South Texas Project Electric Generating Station P.O. Box 289 Wadsworth, Texas 77483

July 20, 2009  
U7-C-STP-NRC-090072

South Texas Project  
Units 3 and 4  
Docket Nos. 52-012 and 52-013  
Responses to Requests for Additional Information

Attachments 1 through 8 provide responses to the following RAI questions:

**Figure 1.** Rupture segments considered in the source model.

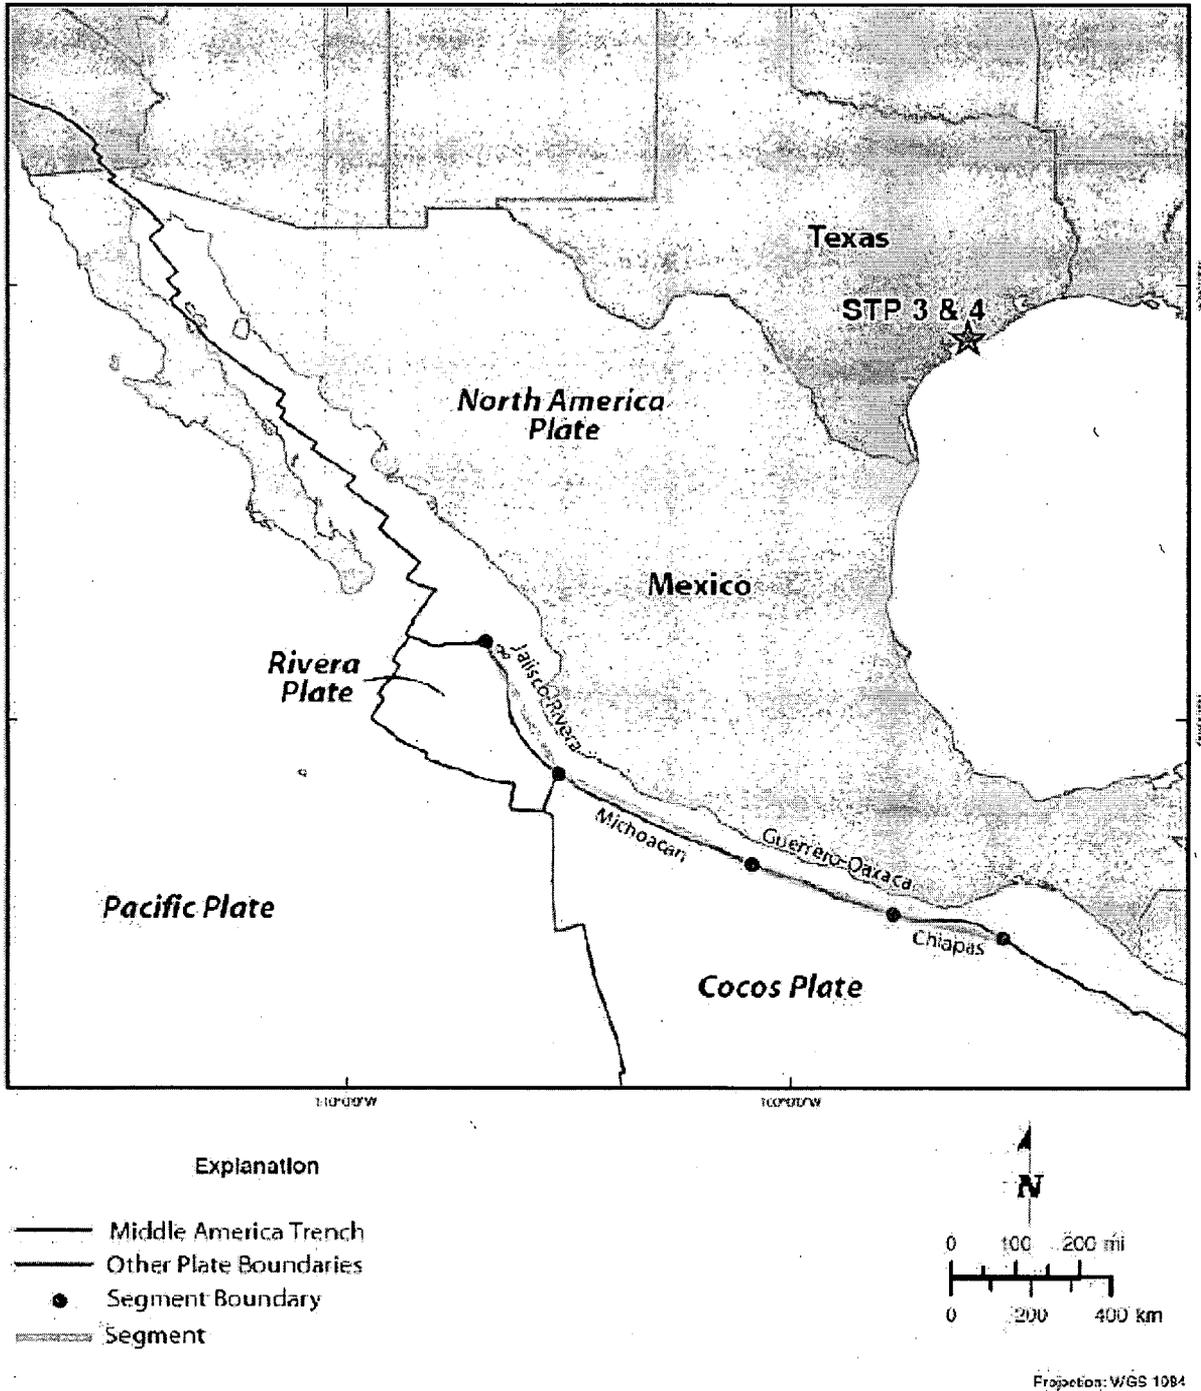
You summarized Mid America Trench sensitivity analysis in FSAR Com 2.5S-1. Please provide detailed contents on this sensitivity analysis, including detailed source characterization, attenuation relationships and other related information.

In the source model the MAT is divided into the four distinct segments, shown on Figure 1, based on: 1) variations in the age of subducted oceanic crust, 2) dip of the subducting plate, 3) extent of historic interplate earthquake ruptures, and 4) the presence or absence of fracture zones and ridges on the subducting plate (Mann et al., 2006; Núñez-Cornú et al., 2002; Pardo and Suarez, 1995; Santoyo et al., 2005; Yoshioka et al., 2004). The historical record of MAT seismicity demonstrates that the MAT has been characterized by single-segment ruptures approximately corresponding to these four segments (Santoyo et al., 2005), but many in the research community believe that most subduction zones, including the MAT, are capable of large multiple-segment ruptures (Ammon et al., 2005; Lay et al., 2005; McCaffrey, 2008). Therefore, the MAT source model includes the possibility of multiple-segment rupture. Specifically, three multiple-segment rupture scenarios are considered: rupture of 1) all of the segments from Michoacan to Chiapas; 2) the Michoacan and Guerrero segments; and 3) the Guerrero and Chiapas segments. The Jalisco-Rivera segment is not included in multiple-segment rupture scenarios because the Rivera plate behaves as an independent plate from the Cocos plate (Bird, 2003; DeMets and Traylen, 2000; DeMets and Wilson, 1997).

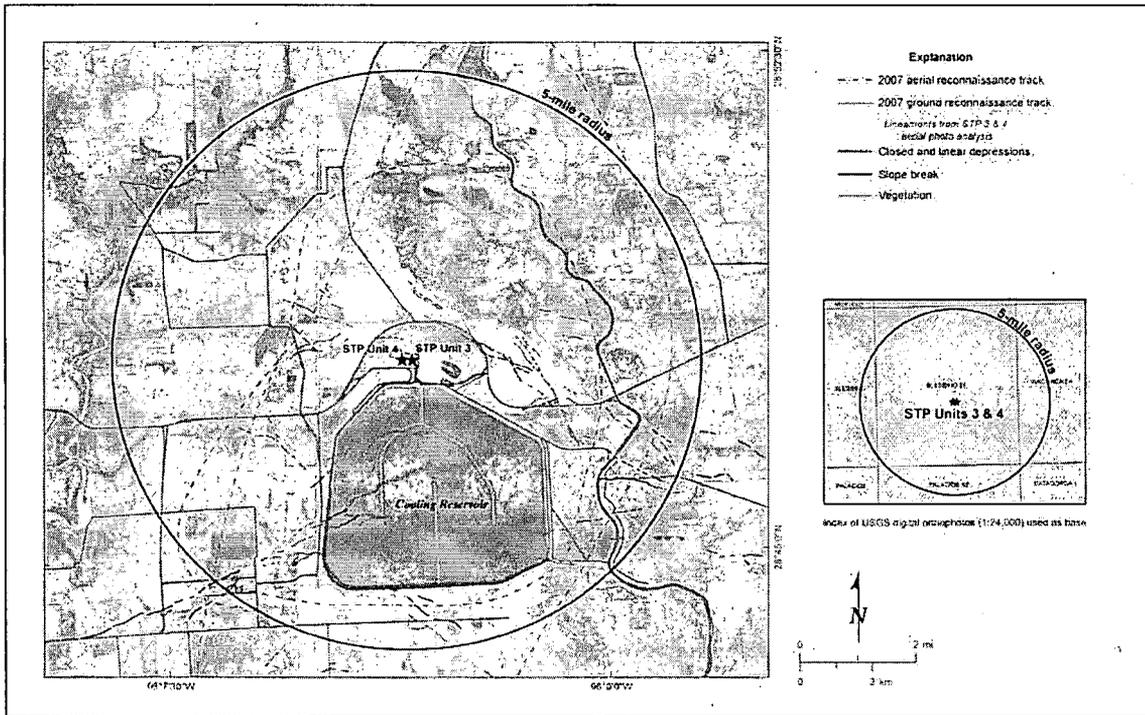
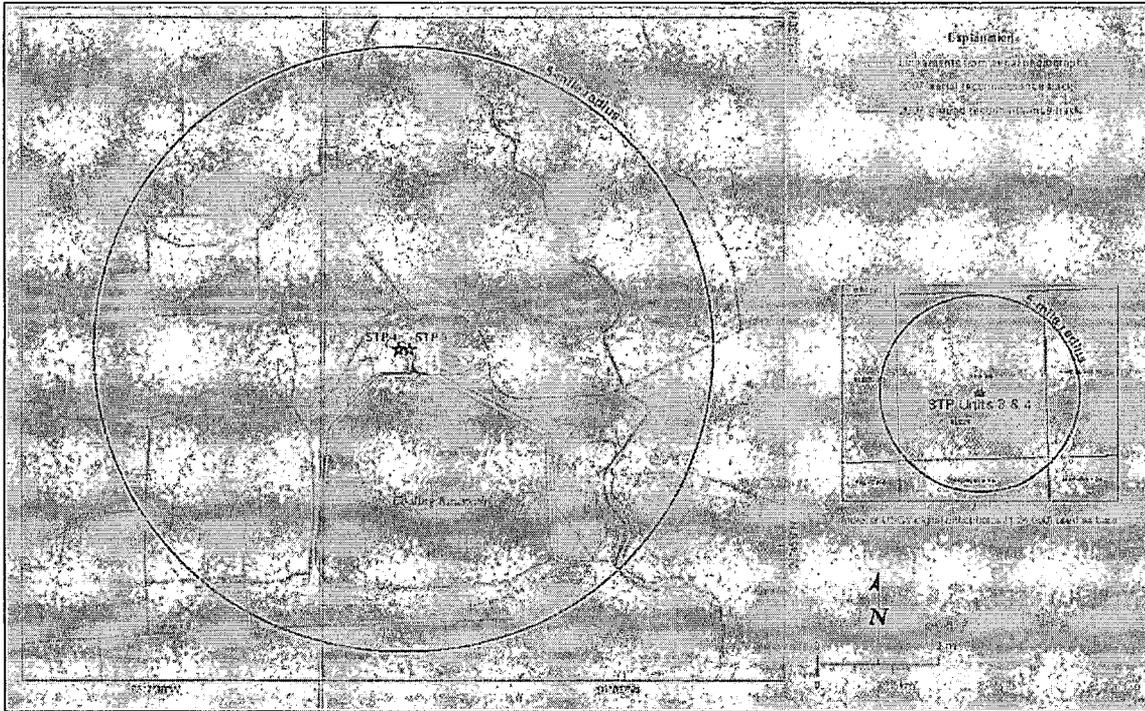
- a.) FSAR figure 2.5S.1-44 suggests that it represents lineament data in addition to aerial reconnaissance and ground reconnaissance tracks. Please revise FSAR Figure 2.5S.1-43, 44, and 45 to include lineament data that is described in the "Explanation", or legend, so that the staff can adequately evaluate the extent of the growth fault investigations within the site area, or within the 5-mile site radius. In addition, please identify which linear features were identified in the investigations for STP Units 1 and 2 and which features were identified in the investigations for Units 3 and 4.

- a.) Revised FSAR Figures 2.5S.1-44 and 2.5S.1-45 were presented in the responses to RAIs 02.05.01-8 (Letter ABR-AE-08000054, July 16, 2008) and 02.05.01-13 (Letter ABR-AE-08000061, August 12, 2008). These revised figures included the location of lineaments identified from aerial photos as part of the STP 3 & 4 investigations. FSAR Figures 2.5S.1-44 and 2.5S.1-45 have been further revised in this RAI response to more clearly indicate within the explanations that the lineaments shown in the figures were identified as part of the STP 3 & 4 investigations. Lineaments identified during the STP Units 1 and 2 efforts are presented in the responses to RAIs 02.05.01-7 and 02.05.01-9 (Letter ABR-AE-08000074, October 1, 2008). FSAR Figure 2.5S.1-43 has not been modified in response to this RAI because that figure does not present and is not intended to present lineaments. The figure is intended to only show the location of growth fault surface projections.

Replace Figure 2.5S.1-44 with the revised version shown below:
